Memorandum

Subj: Mediterranean Village – Coral Gables, Florida
Responses to Outstanding Transportation/Parking Items

The purpose of this memorandum is to provide updates/responses addressing outstanding transportation/parking related items identified by City Planning and Zoning staff the week of May 18, 2015. Note that this memorandum serves as a follow up the supplemental information provided to City staff on the traffic impact study, valet operations study, and shared parking study dated May 18, 2015. The following summarizes updates/responses to these outstanding items:

ATTACHMENT E:
BICYCLE CIRCULATION PLAN

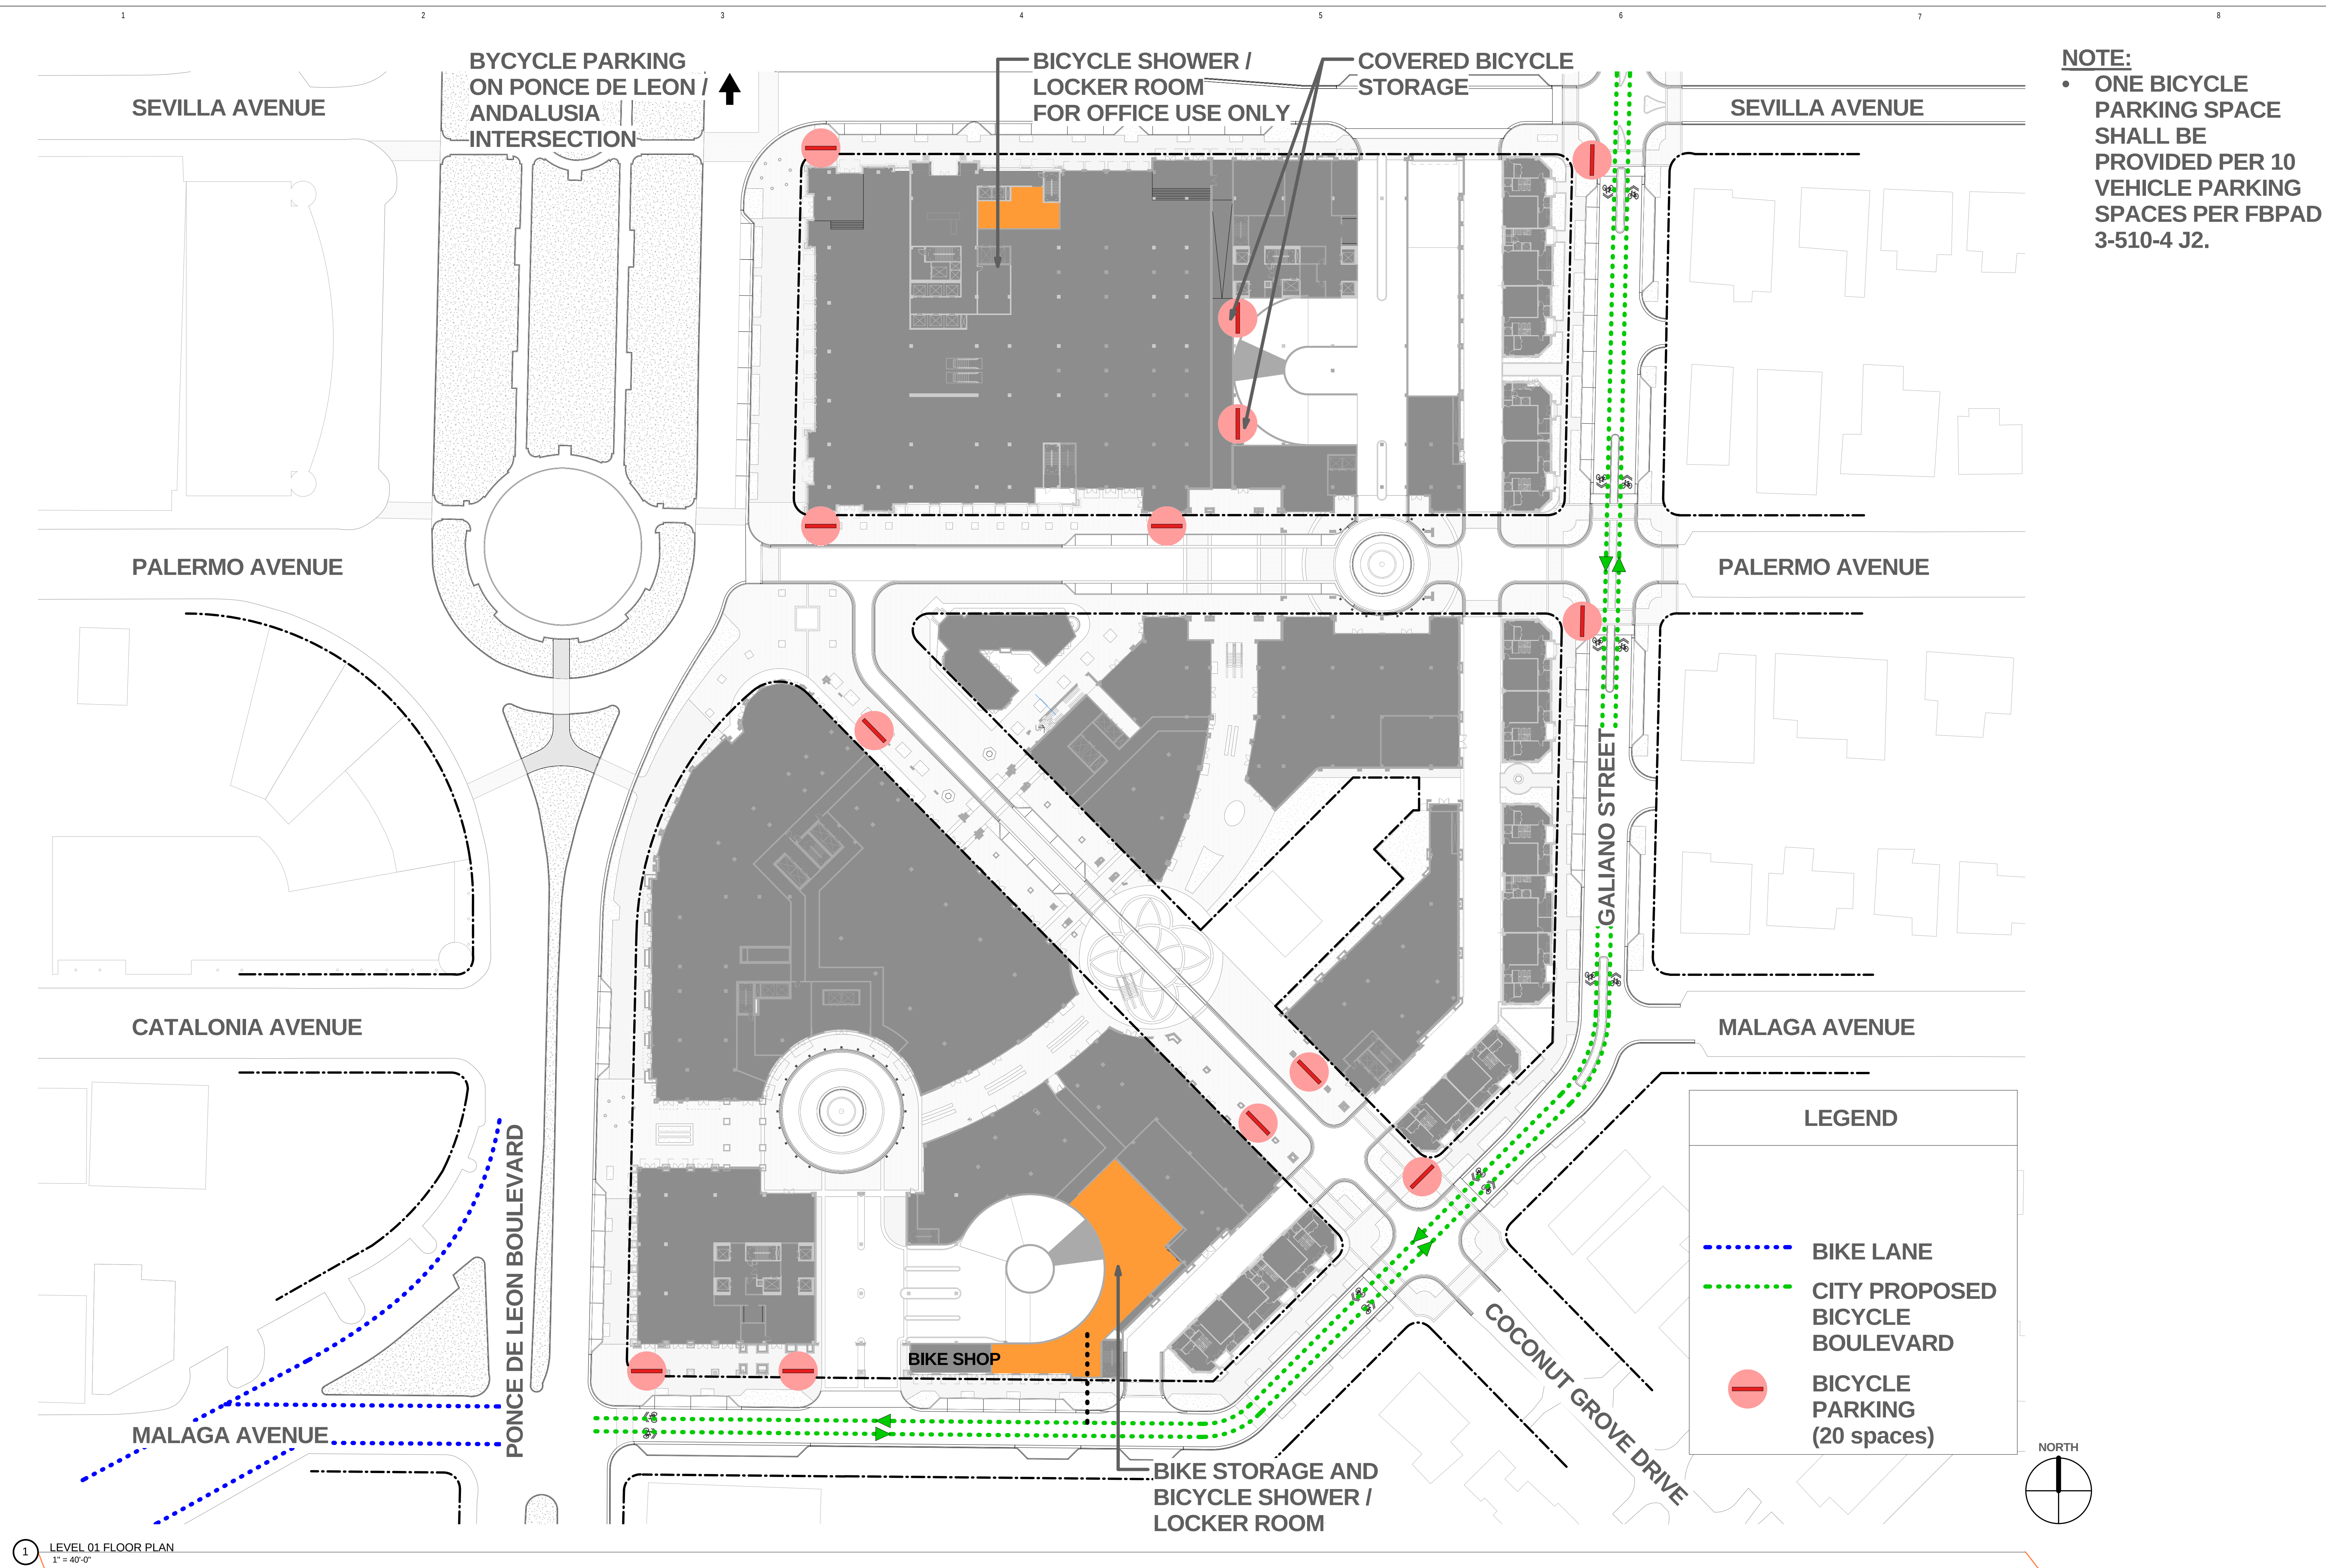
7. Galiano Street Bicycle Friendly Design

City staff has requested that Galiano Street be design to encourage cyclist use. The developer is committed to designing and constructing Galiano Street/Malaga Avenue on the perimeter of the site consistent with bicycle-friendly features including, but not limited, to signing and pavement markings. Refer to Attachment E.

Proposed Intersection Improvements
Ponce De Leon Blvd at Malaga
Avenue/University Drive

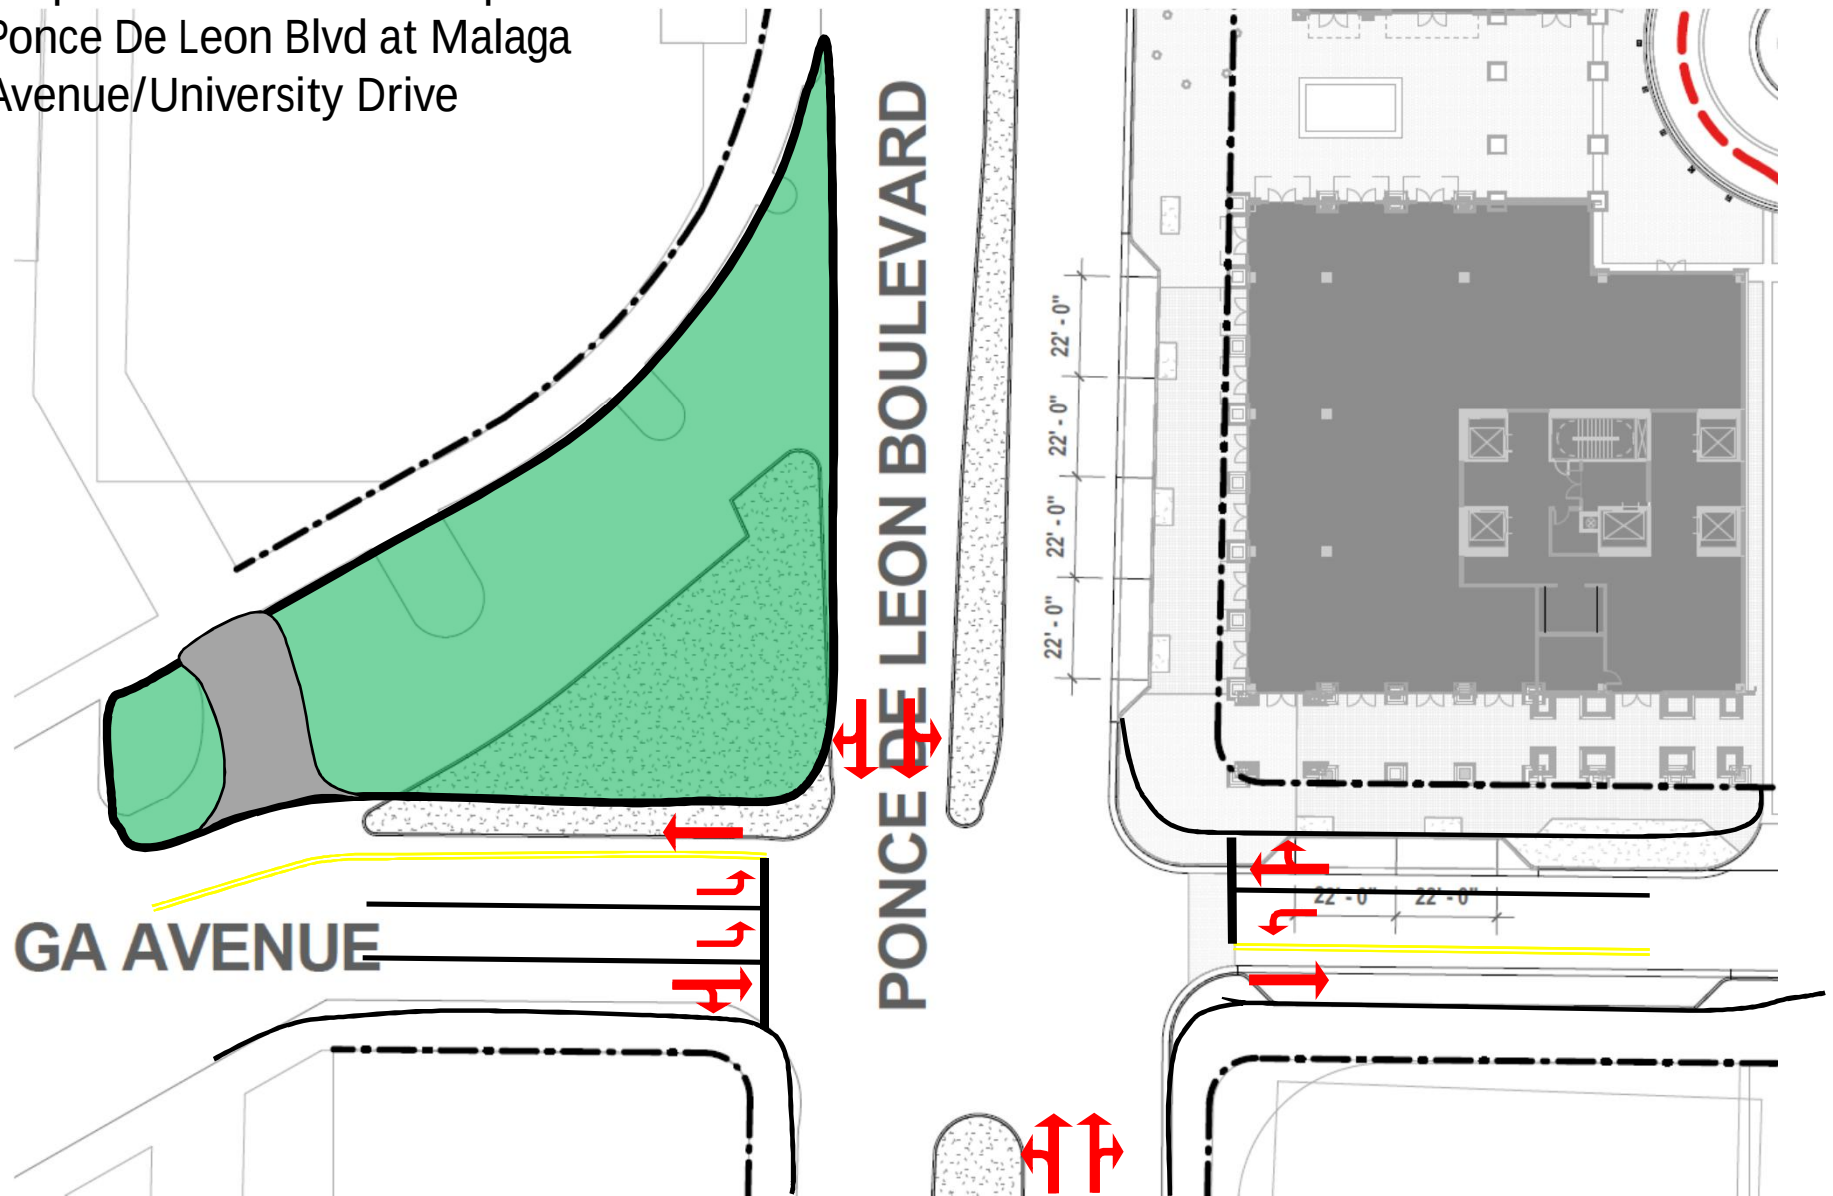
Note that currently the signalized intersection of Malaga Avenue and Ponce De Leon Boulevard currently operates with east-west split signal phasing due to the limited number of approach lanes along the minor street. At the request of both City staff and Miami-Dade County's Traffic Engineering Division staff, this updated analysis examined the impacts of geometric improvements that will allow for the elimination of east-west signal phasing. The improvements would require the following:

- Widening of the eastbound approach (west leg) to the north to provide for two (2) eastbound exclusive left-turn lanes and one (1) shared through/right-turn lane.
- Widening of the westbound approach (east leg) to the north to provide for one (2) exclusive westbound left-turn lane and one (1) shared through/right-turn lane. This widening will require the elimination of the on-street parking lane previously proposed as part of the proposed development.

In addition, City staff requested that the free-flowing, separated southbound right-turn movement from Ponce De Leon Boulevard to University Drive be eliminated and the right-turn movement to occur at the signalized intersection. Refer to Attachment D for a conceptual sketch of the proposed improvements. An operational analysis for the intersections of University Drive/Ponce De Leon Boulevard, Malaga Avenue/Ponce De Leon Boulevard, and South Driveway/Malaga Avenue was conducted using the same methodologies from the previous traffic impact analysis submittal. As Tables 3 and 4 indicate, all intersections are expected to operate at LOS D better under future total traffic conditions with and without the suggested improvements. Refer to Attachment E for detailed operational analysis results.
